GROUP	MODEL
	ELE	2023-2024MY Sportage (NQ5 HEV)
	NUMBER	DATE
	399	September 2025

TECHNICAL SERVICE BULLETIN

BMS DISCHARGE LOGIC IMPROVEMENT

Upgrade Event #824 (NQ5 HEV)

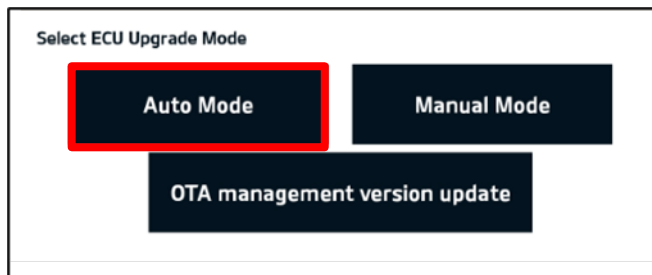
Model	System	IMMO 	ECU P/No.	ROM ID	
				Previous	New
SNQ5 HEV	BMS (Battery Management System)	Yes	37513 CH000	6080	6180
				6100	
				6120	
				6140	
				6160

To verify the vehicle is affected, be sure to check the Calibration Identification of the vehicle's ECM ROM ID and reference the Information Table as necessary.
